Question Number	Topics or Referenced Document	Date of Question	Date Replied	Question	Response
1	CDCDC 2 - 2020 RFP Package – HFI Lab Construction – IFB rev0	April 6, 2026	April 20, 2026	6.3 Payment Terms: Prompt Payment - The proposed 45-day payment timeline is in contravention with the prompt payment requirements of the Ontario Construction Act.	HFI will follow the Canadian Construction Documents Committee (CCDC 2 - 2020). As per section 5.3.1.2 <i>“Payment will be on or before 28 calendar days after the receipt by the Owner and the Consultant of the application for payment, and in any event, in compliance with Payment Legislation.”</i>
2	RFP Package – HFI Lab Construction – IFB rev0	April 6, 2026	April 20, 2026	6.3 Payment Terms: Please confirm that the proposed retainage is separate from the statutory holdback required by the Ontario Construction Act.	There will be no separate retainage outside of the statutory holdback. Monthly progress payments will be based on certified completed work, retaining a 10% statutory holdback on each payment in accordance with the Ontario Construction Act. The holdback retained for the Work shall be released 45 days after the date the Certificate o

Figure 4 - a) dimensions requested at the paved ditch area

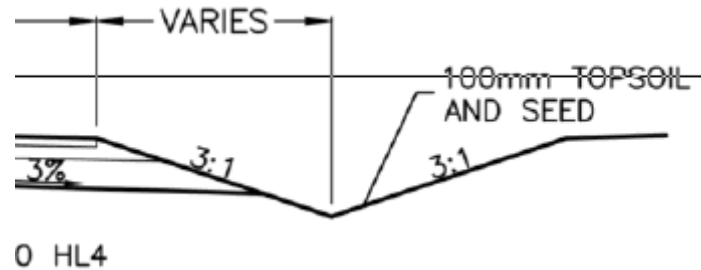
<p>roadway to the west of lab building. Addendum to follow.</p>
<div style="text-align: center;">  <p>Figure 3 - Drawing E2 Excerpt</p> </div>					
12	C3	April 9, 2026	April 29, 2026	<p>It's not clear but for topsoil and seeding can you please supply the following</p> <ul style="list-style-type: none"> a) Can you please get us dimensions at the paved ditch area, both sides b) Extent around the building, does it cover grading area note 13 & 18 on A020 	<p>Note Specification section 32 92 23 Sodding (not seeding). Total landscaped area 6061m², less area of road at 1903m² and area of building at 735m².</p>

Figure 7 – Drawing C3 Excerpt

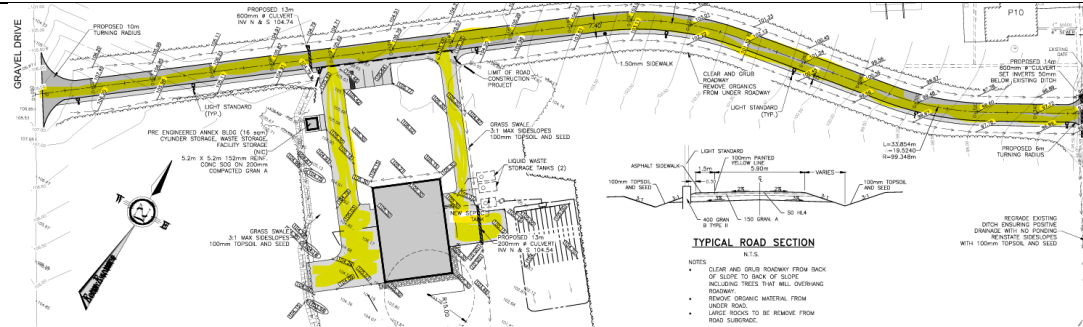
30	C3	April 15, 2026	April 20, 2026	Architectural drawings indicate that the main access road is not included in this contract and will be completed by others. Can you please delineate the limit of the scope of work on the civil drawings for what we are to include in this contract?	The new main access road, "service road" will be included in this contract and bids should reflect that. On C3, all roads shown are part of this contract. Provided below is a screenshot of drawing C3 with roads to be built highlighted in yellow.
